NEW JERSEY HIGHLANDS COALITION

February 17, 2012

Re: Draft Environmental Assessment and Finding of No Significant Impact (dEA/FNSI) for Building and Operating a Safe Armaments Facility for Energetics Research (SAFER) at Picatinny Arsenal (PICA), New Jersey

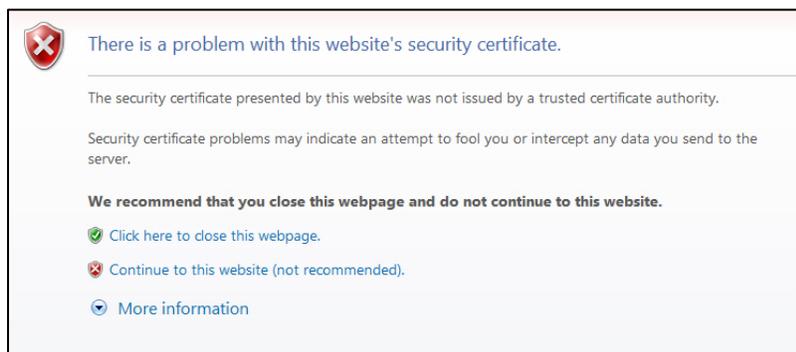
What I found particularly troubling in these daunting quests for basic information was how pervasively the door was shut on public scrutiny of the dEA/FNSI. For example, the only public access to the dEA/FNSI is by navigation to the Environmental Affairs section of the PICA website. Once there, the first time visitor using the Firefox browser is greeted with this message:

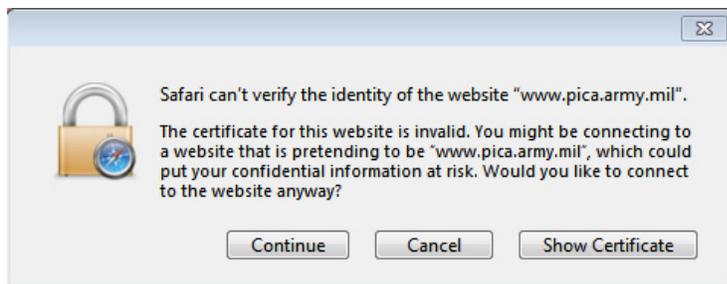
And Safari users see:
